REMARKS

I. THE PRESENTLY CLAIMED INVENTION

Figure 1

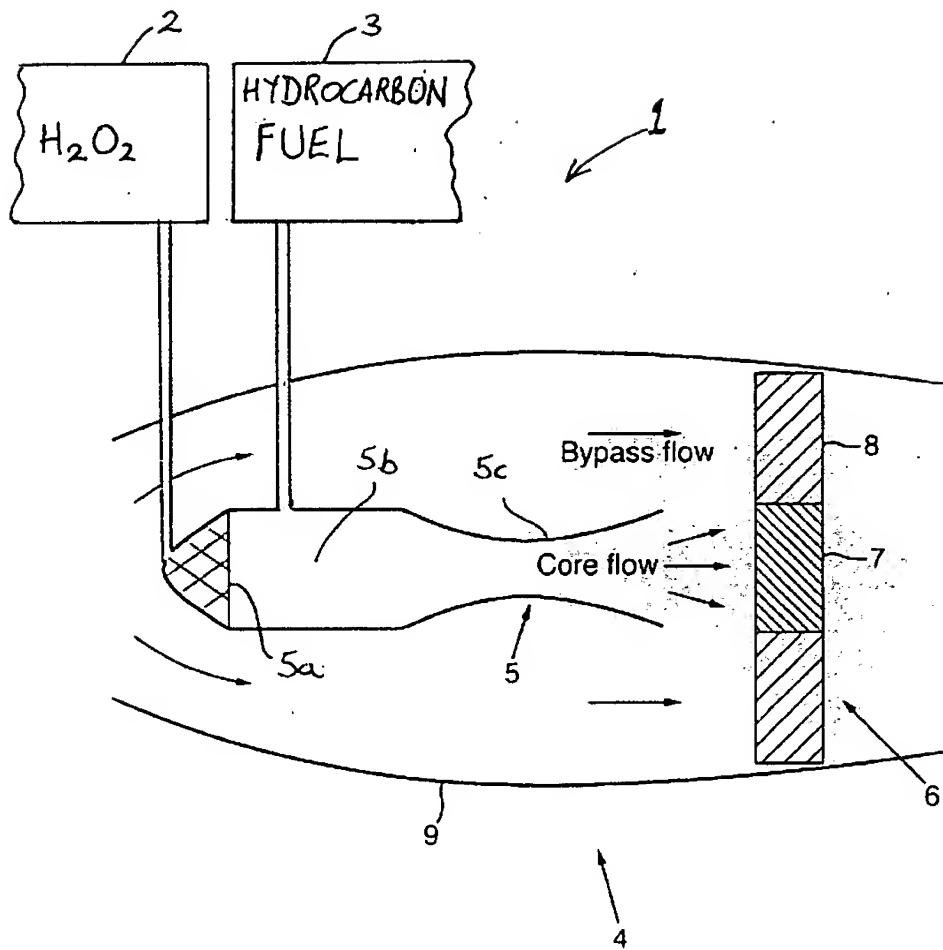
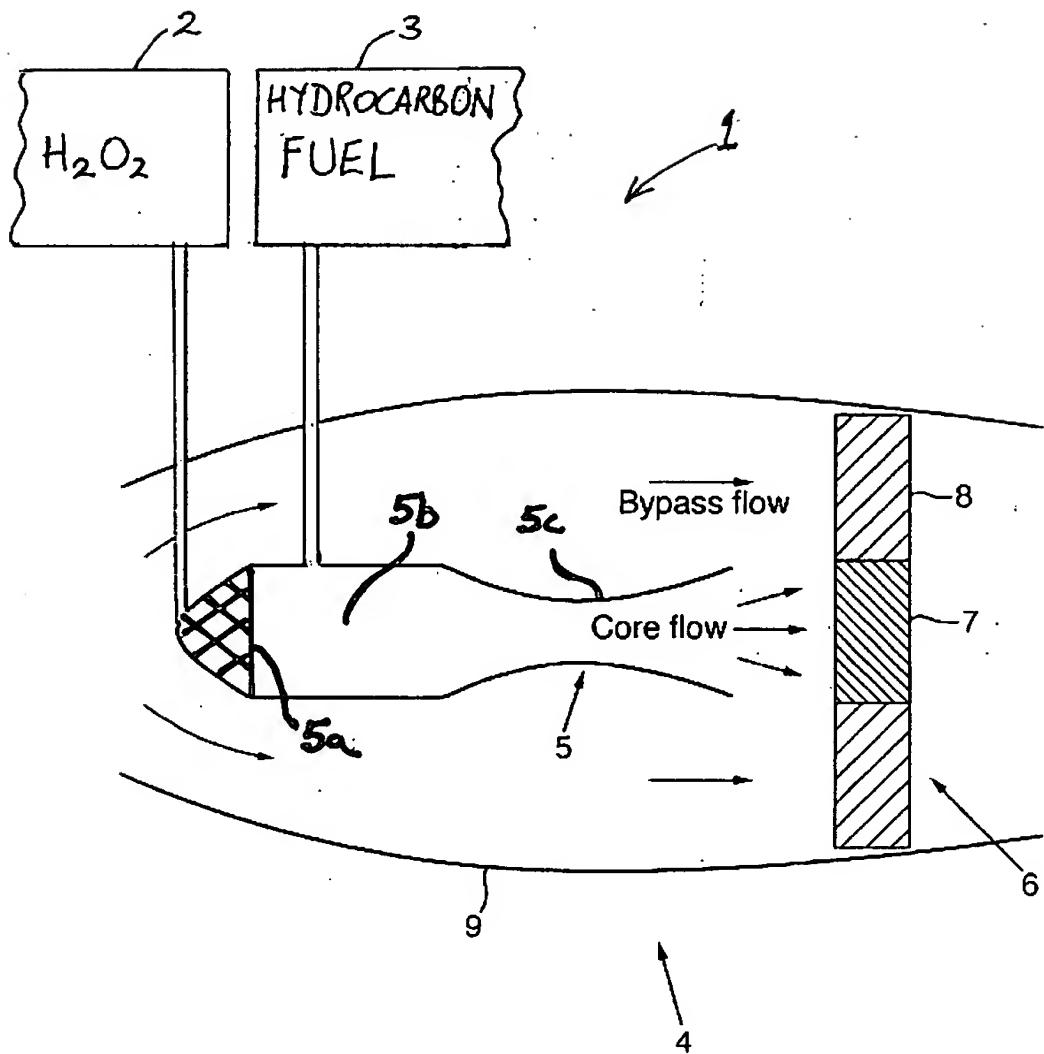
The Examiner objected to the drawings under 37 CFR 1.83(a). The Examiner explained that the drawings must show the decomposition region and the combustion region as described in the specification and claims.

Claims 10, 14, 18 and 22-24 are pending in the Application. Claims 11-13, 15-17 and 19-21 have been canceled from the application without prejudice. New claims 22-24 have been added to the application. Figure 1 has been amended, as required by the Examiner, to include numeric designations for certain features disclosed in the specification but not identified in Figure 1. No new matter has been added to the drawings, the specification or claims by way of these amendments.

The Examiner's objection has been overcome by amending Figure 1 to include numeric designations for the decomposition region with catalyst (5a), combustion region (5b), and nozzle (5c). The specification has been amended accordingly to include the same numeric designations – 5a, 5b, and 5c in the description of the Figure 1 features. These features find support in the specification at, for example, page 1, lines 15-20 and page 2, lines 15-22.
